PERMIT CHANGE TRACKING FORM

Title of Change: **Amendment to relocate; Water Treatment Plant, ROM Transfer and Tipple Electrical Facility**

Permit Number: **ACT / 015 / 009**
 Mine: **Trail Mountain**
 Permittee: **PacifiCorp**

RE: Amendment to Relocate Water Treatment Plant, ROM Transfer, and Tipple Electrical Facility and to Update Reclamation Cost Estimate, PacifiCorp, Trail Mountain Mine, ACT/015/009-94A, Folder #2, Emery County, Utah

FIGURE 3-4 CULINARY WATER SYSTEM

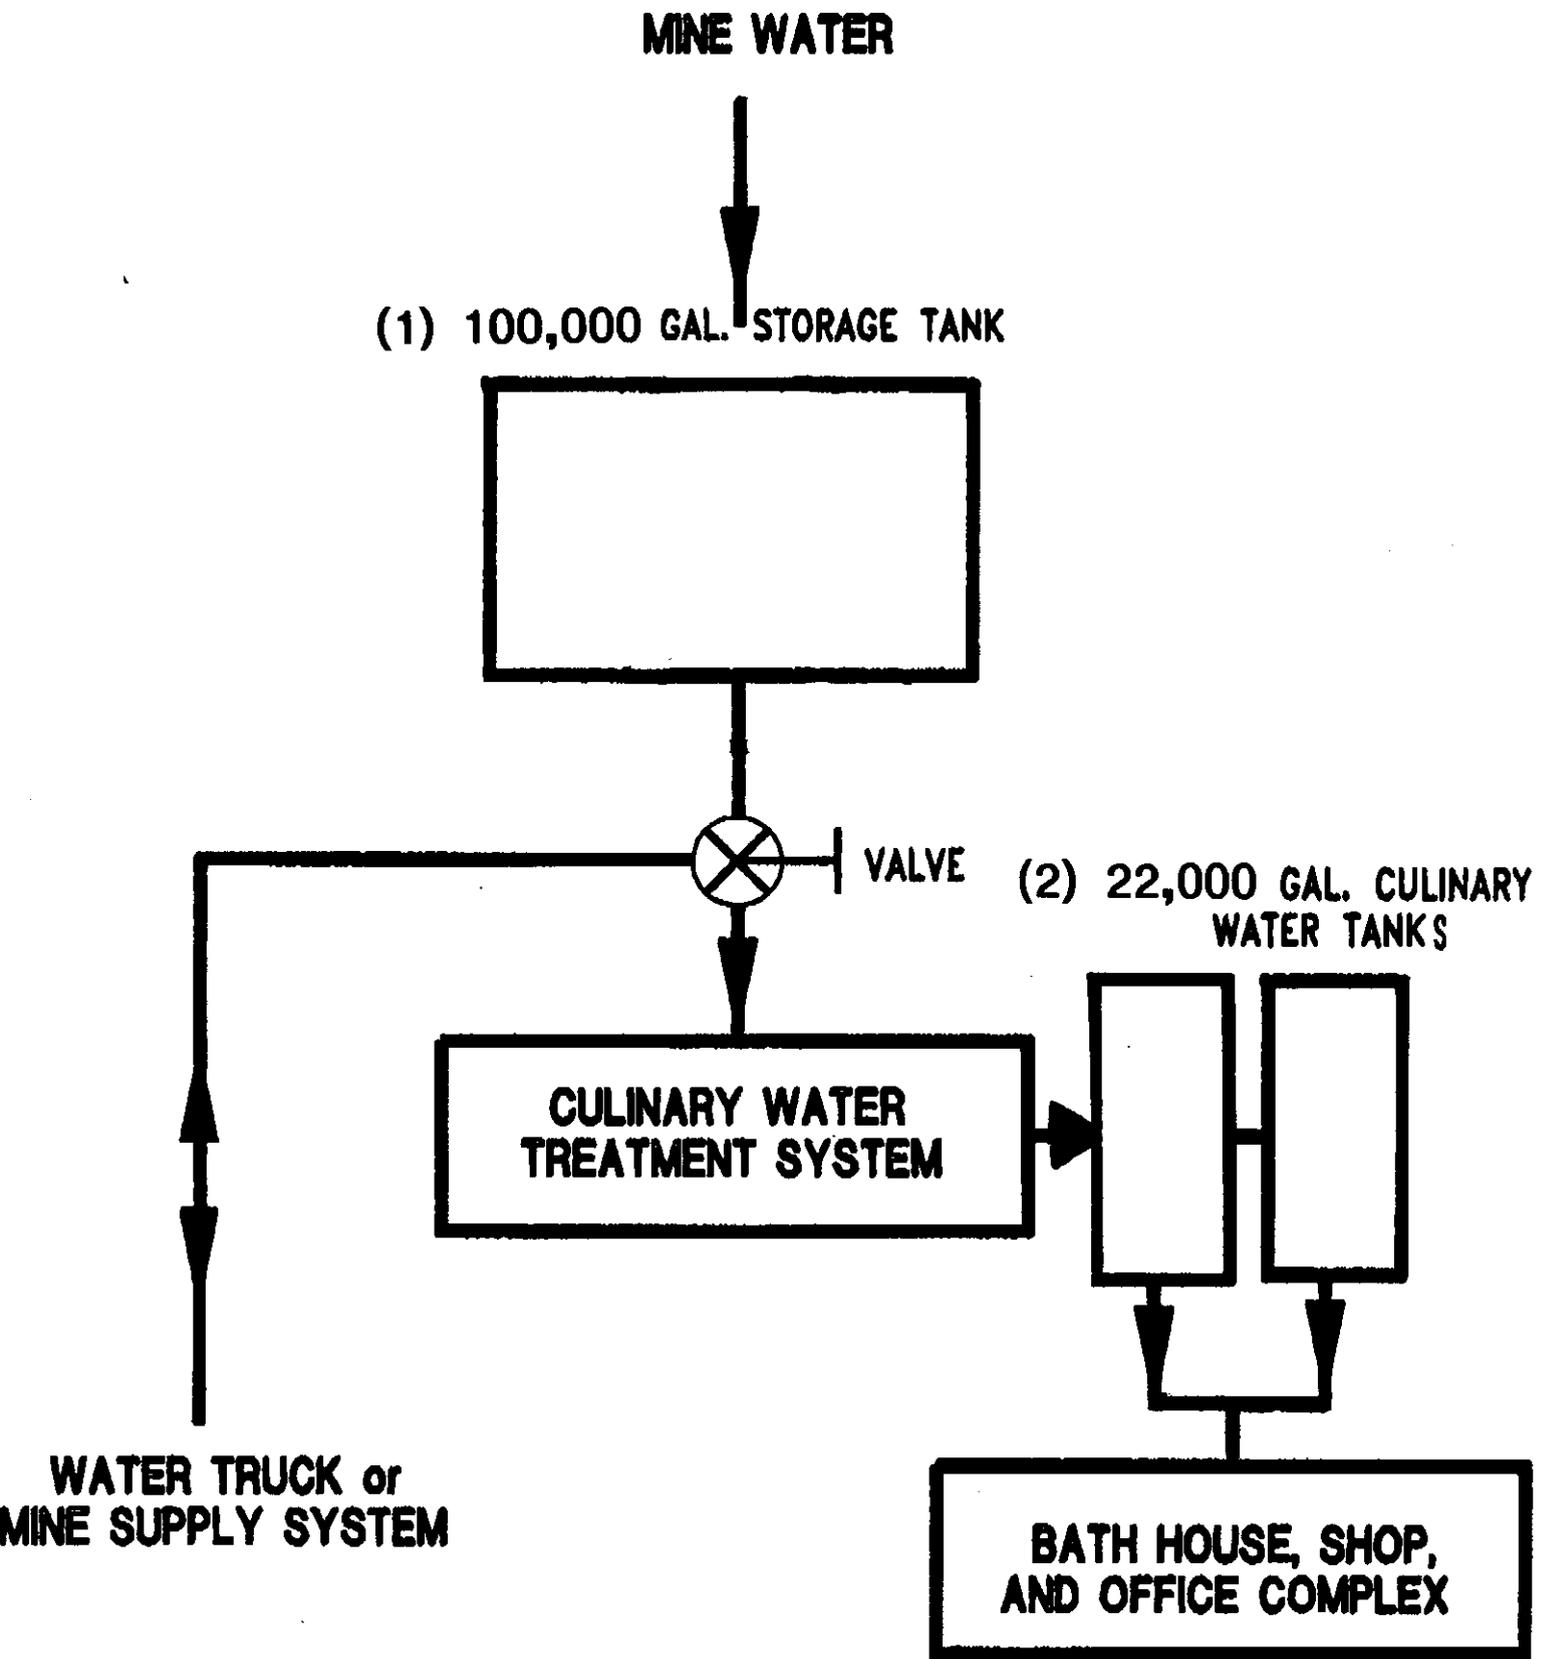
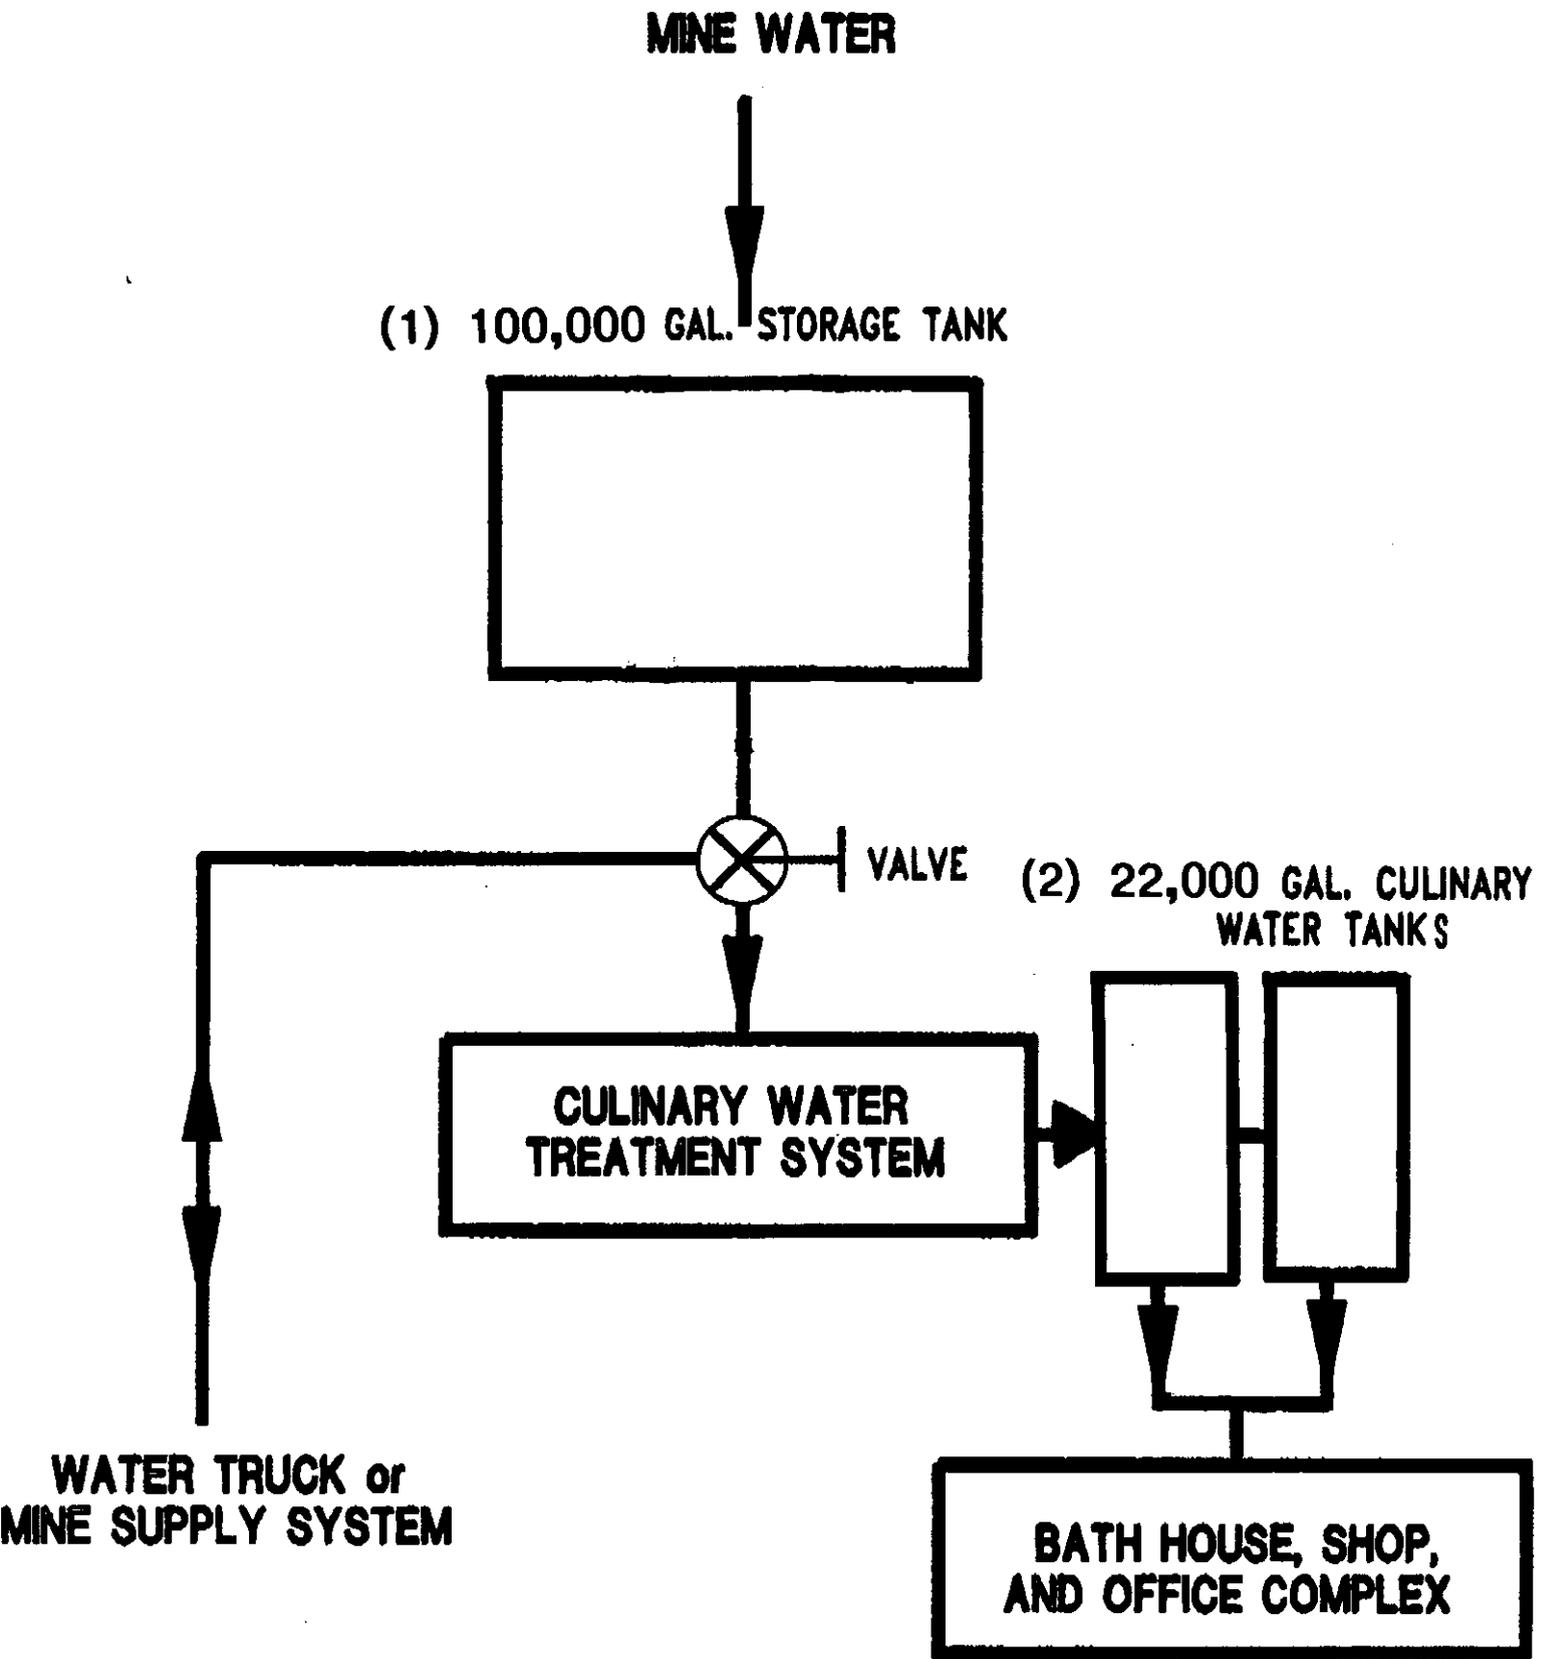
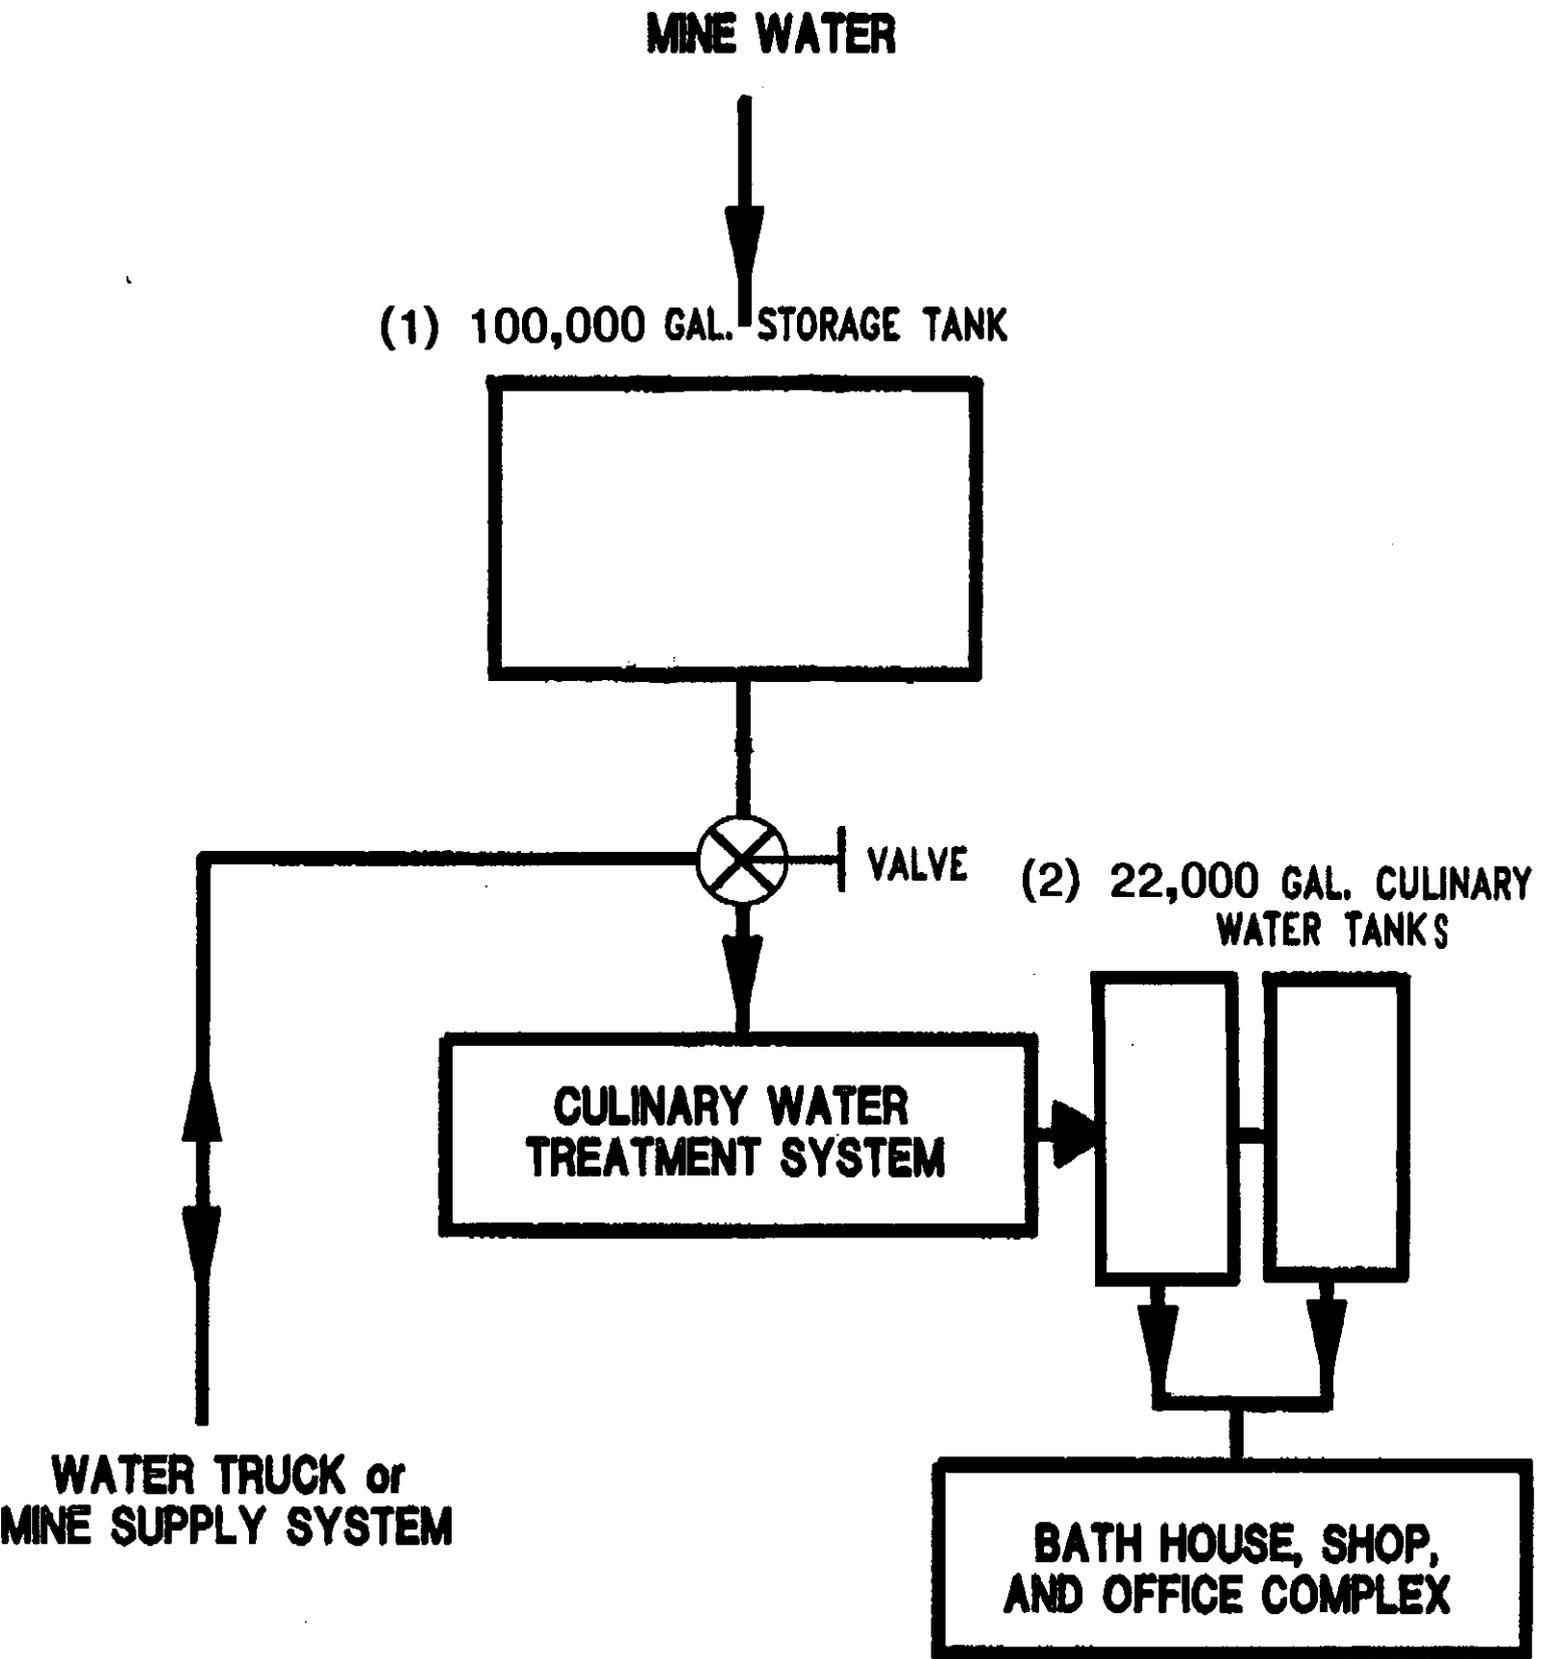
- (h) Water Treatment Plant - The water treatment plant was relocated from the parking area to an area adjacent to the pumphouse and water tank in 1994.**
- (i) ROM Transfer - The ROM Transfer was relocated slightly and structural changes were done in 1994.**
- (j) Tipple Electrical Facility - The Tipple Electrical Facility was removed from the upper bench and a new building was built on the crusher bench in 1994.**

PROPOSED
PLACEMENT OF
2-22,000 GAL
PRODUCT TANKS
& 16'x25' WATER
TREATMENT Bld.

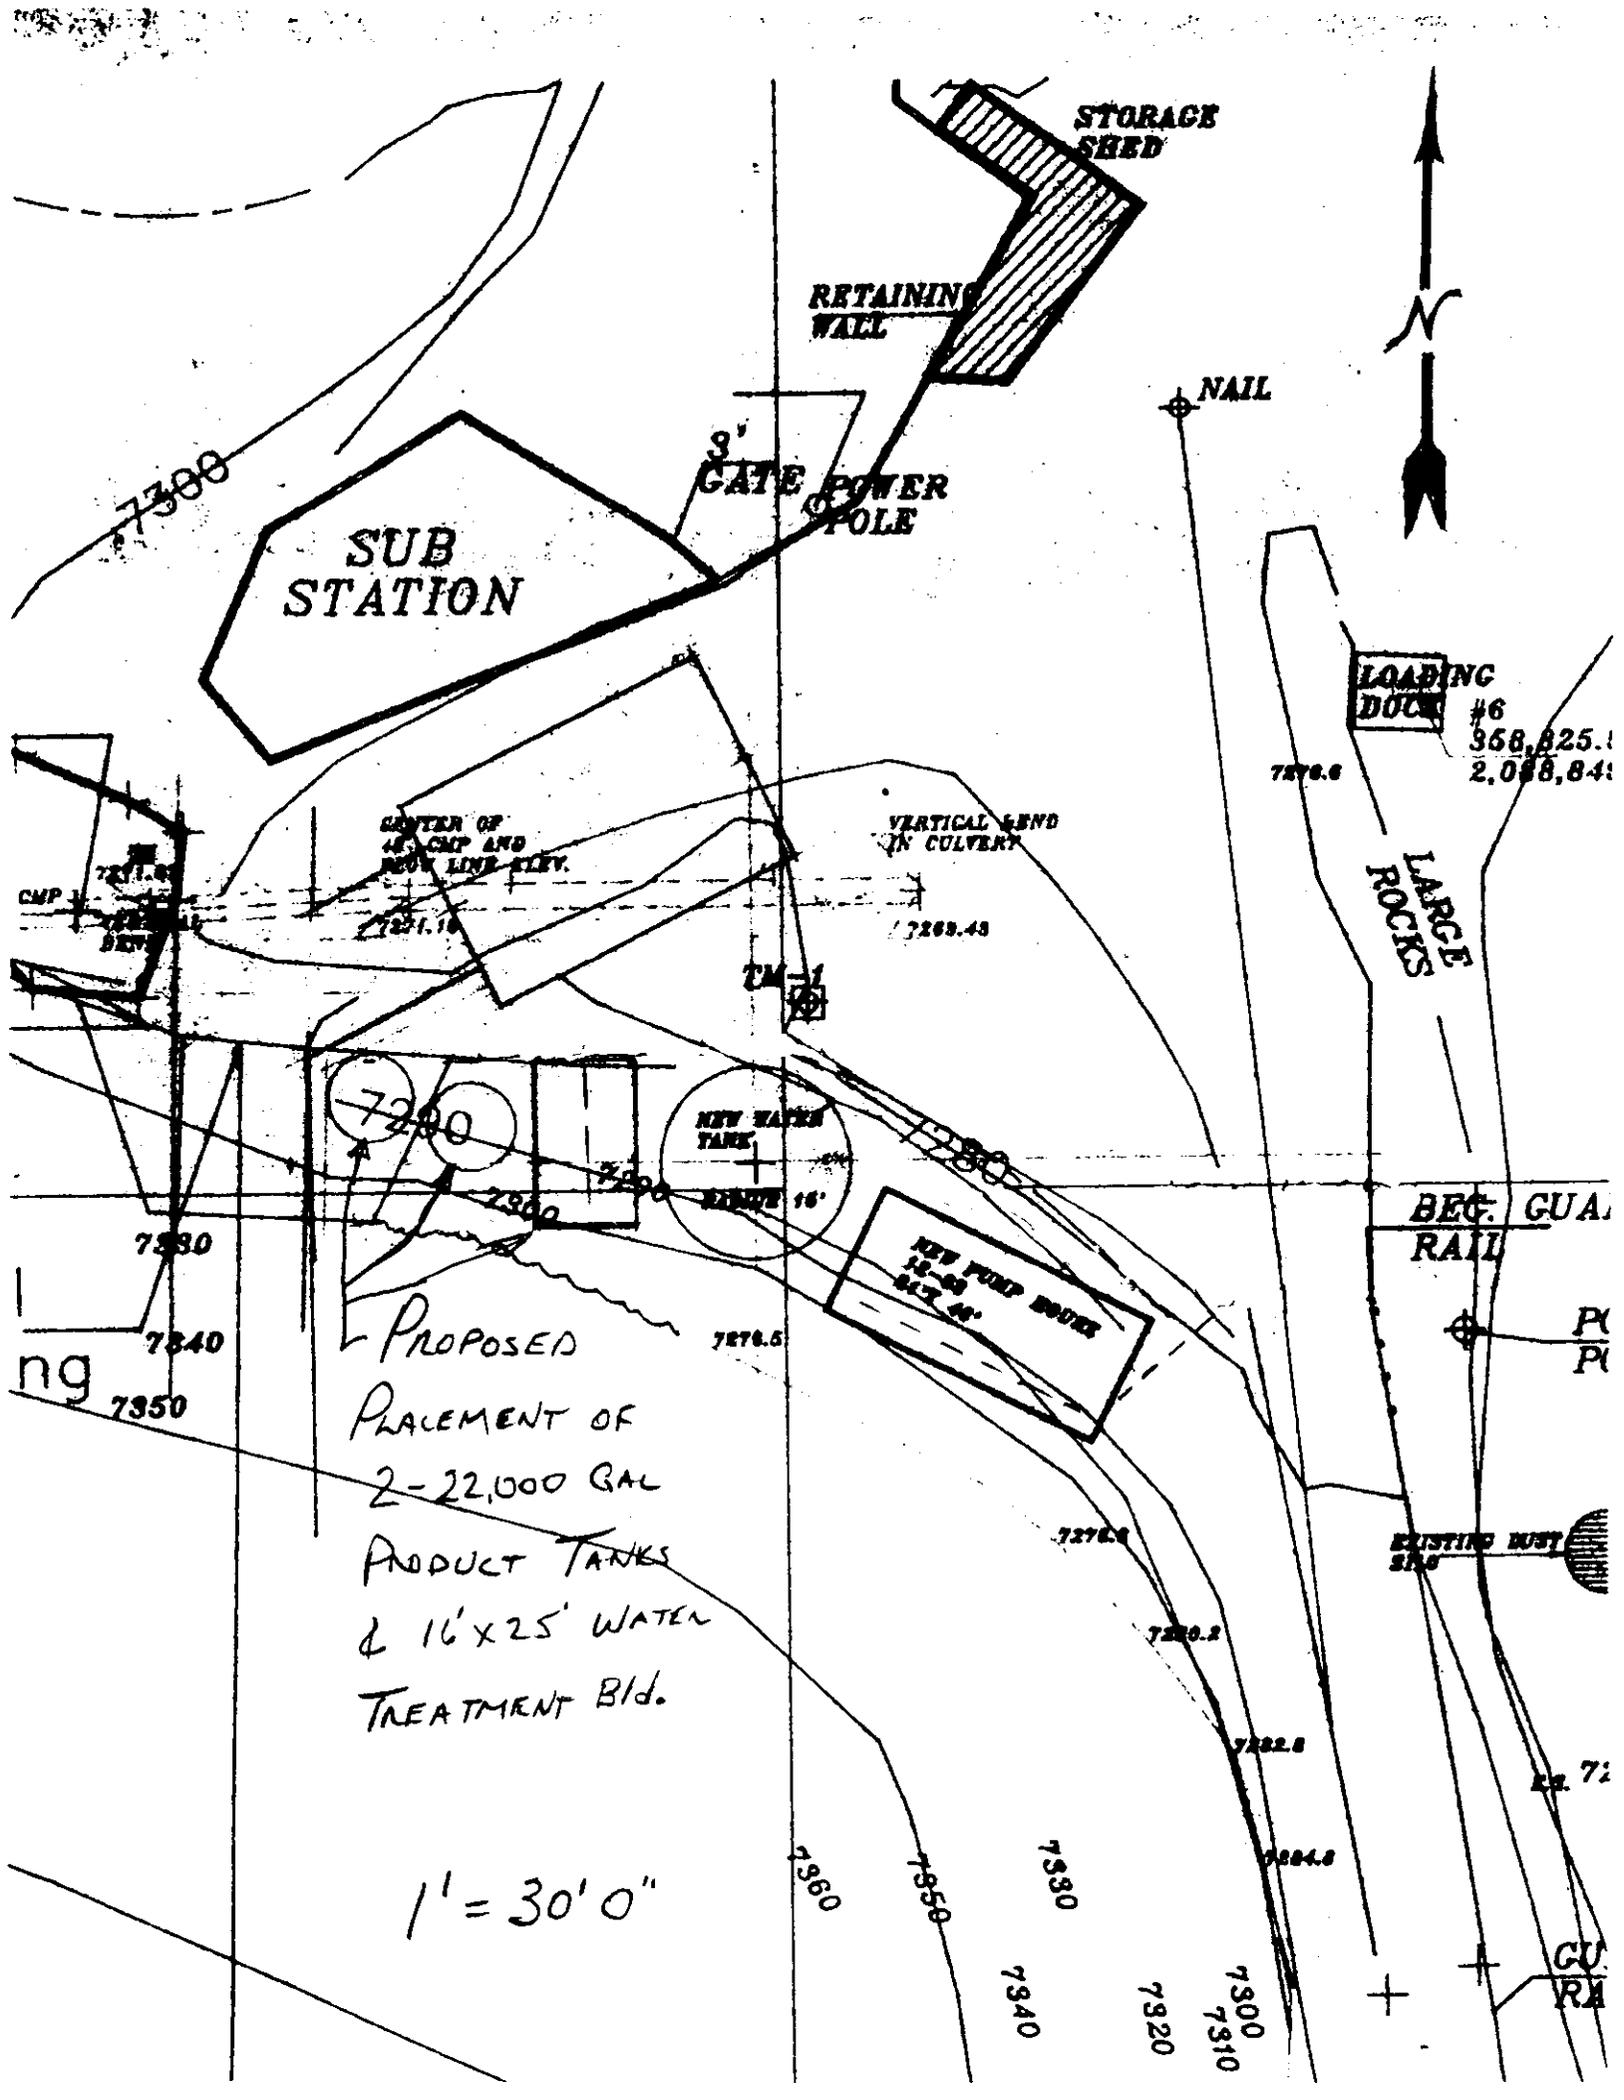
The relocation of the Water Treatment Plant will put it adjacent to the newly constructed High Pressure Water Tank and Building (see enclosed map). This relocation will still place the Water Treatment Plant on the existing disturbed area with all surface drainage reporting to the sediment pond. Four (4) 22,000 gallon tanks are presently used with the Water Treatment Plant as follows; two (2) for raw water, one (1) for product water and one (1) is empty but used as spare product water tank. The relocation will eliminate the two (2) raw water tanks. The two (2) remaining tanks used will be for product water. Raw water storage will come from the existing high pressure tank. Since two tanks are being eliminated and the remaining facility is being relocated no additional reclamation costs will be incurred.
